VILLAWOOD

LEVEL 6 PLAN

Project no. 923 Dwg #. A109

DA - ADDITIONAL INFORMATION

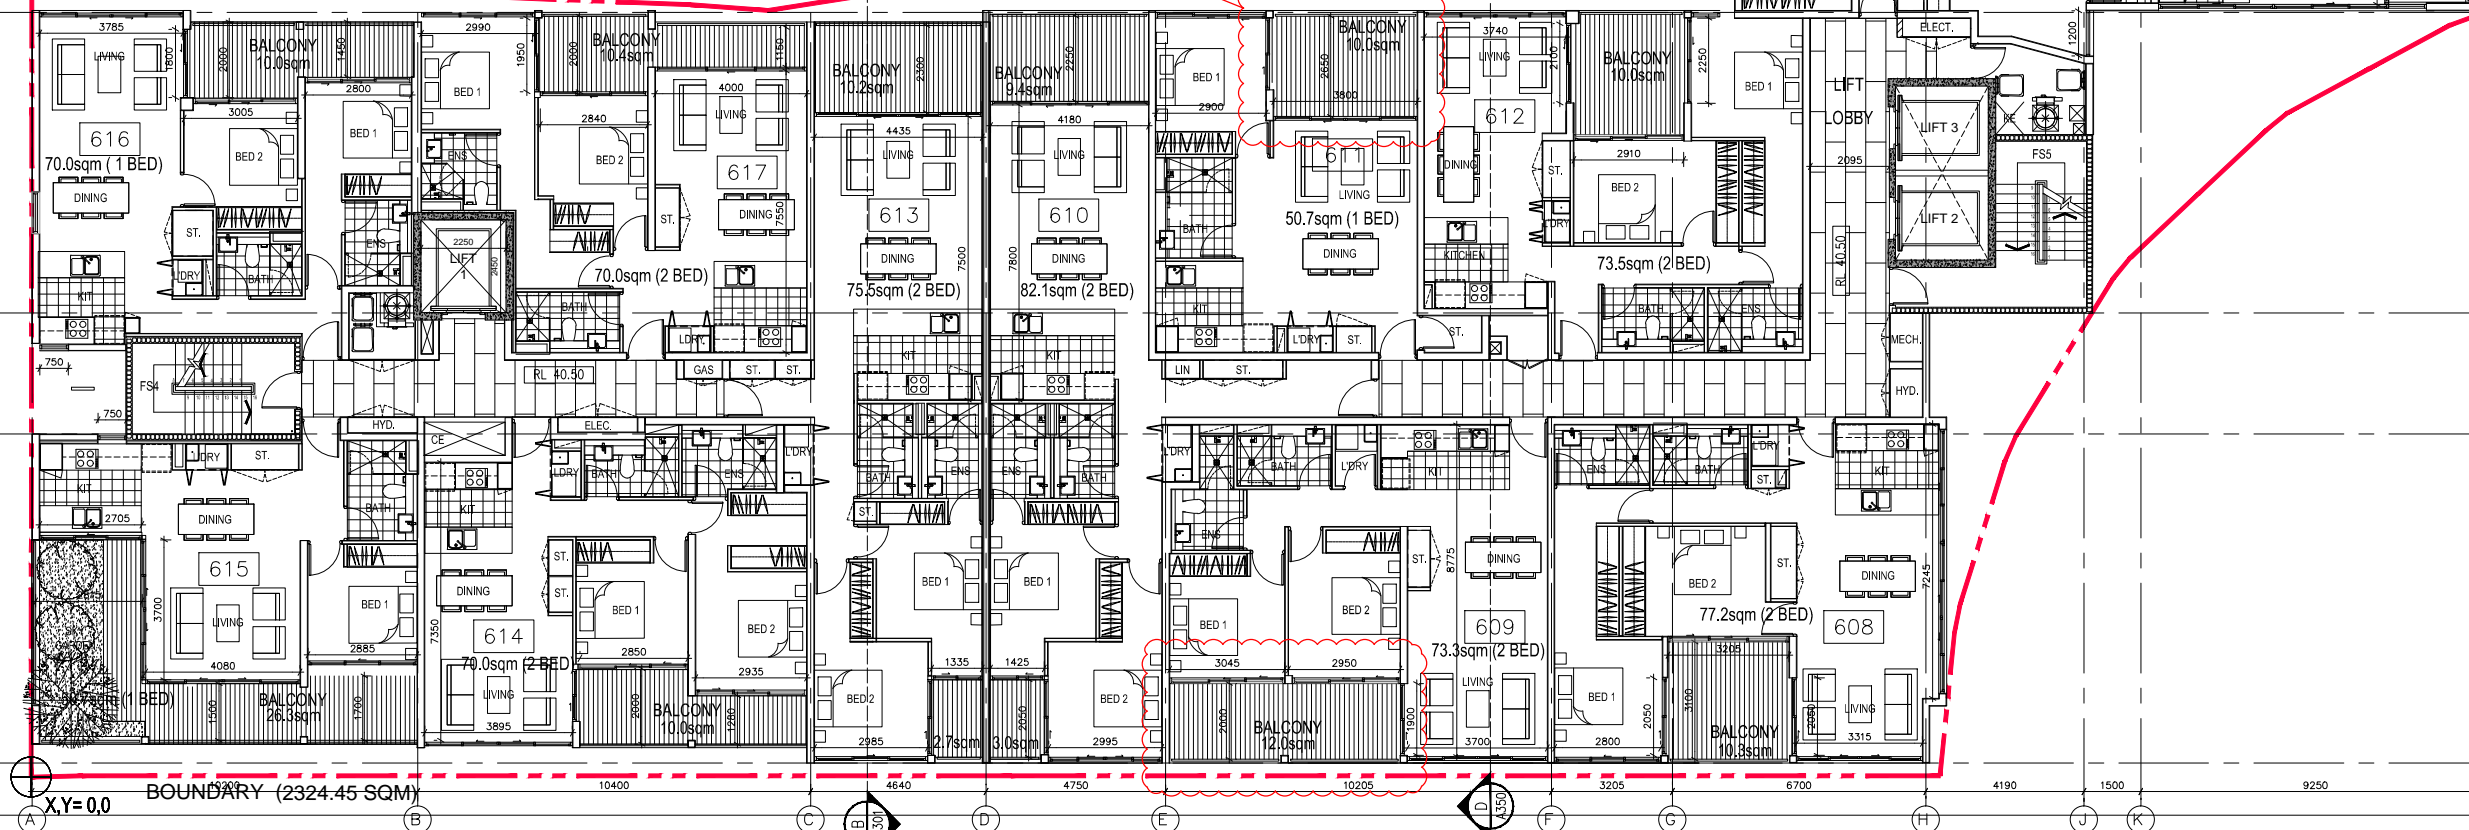
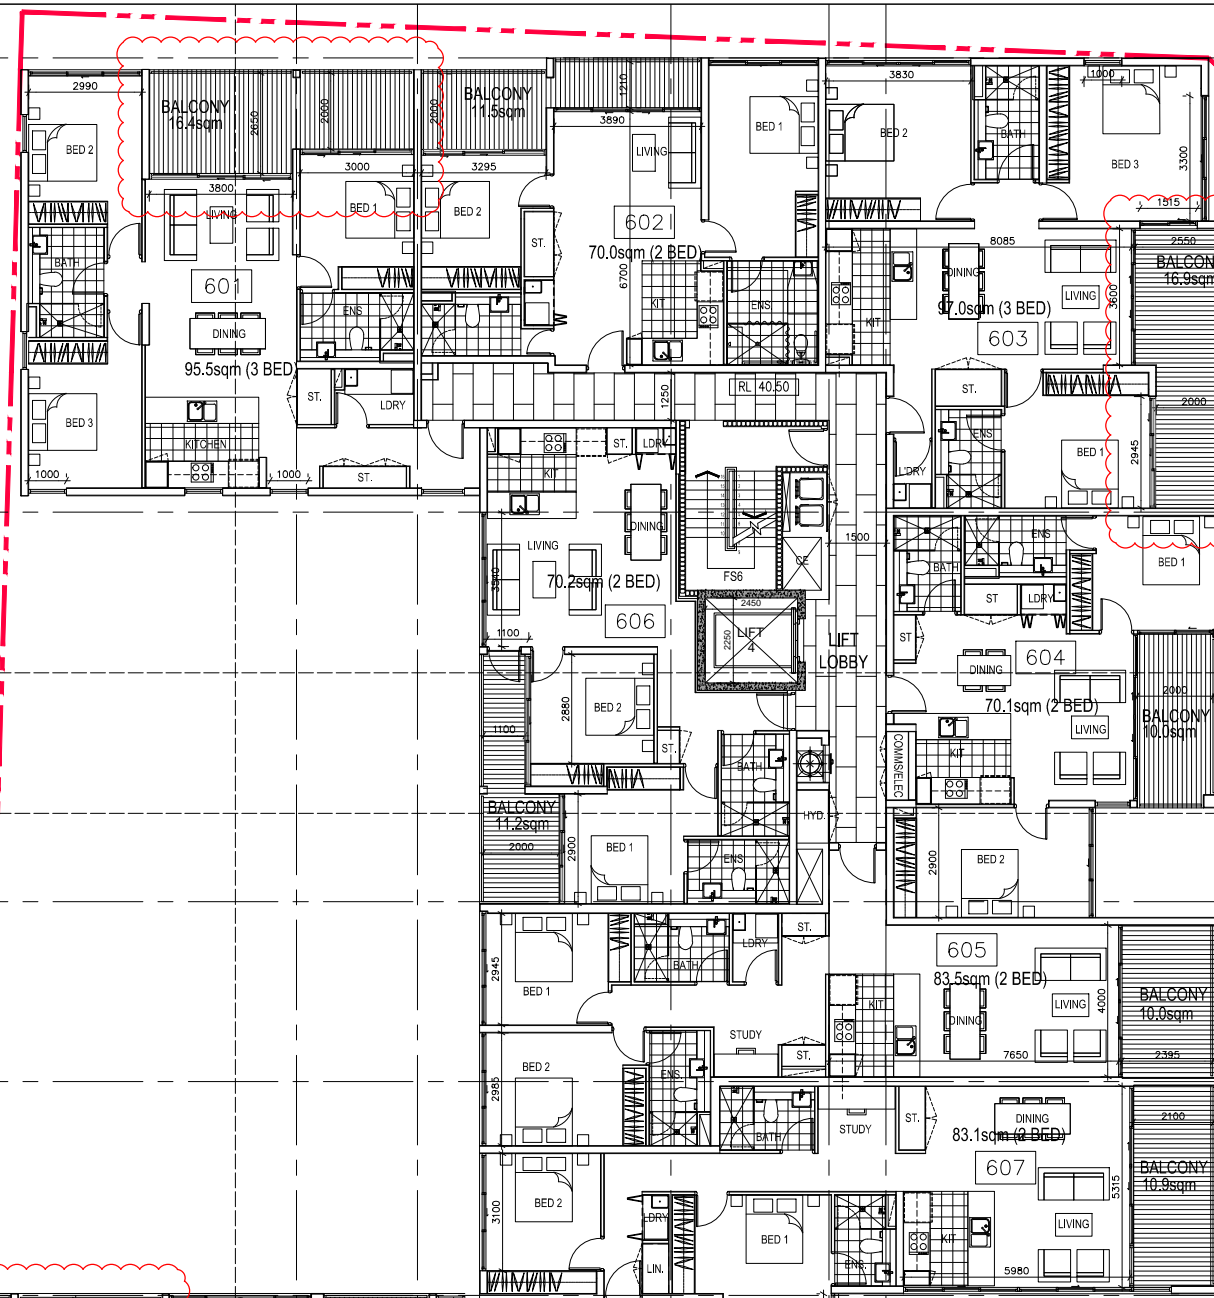
ALL OPENINGS WITHIN 3 METRES OF THE SOUTHERN BOUNDARY ARE TO BE PROTECTED IN ACCORDANCE TO BCA CLAUSE C3.4.

BALCONY DEPTH INCREASED TO ≥ 2 METERS IN DEPTH. (AS SHOWN IN CLOUDED AREAS)
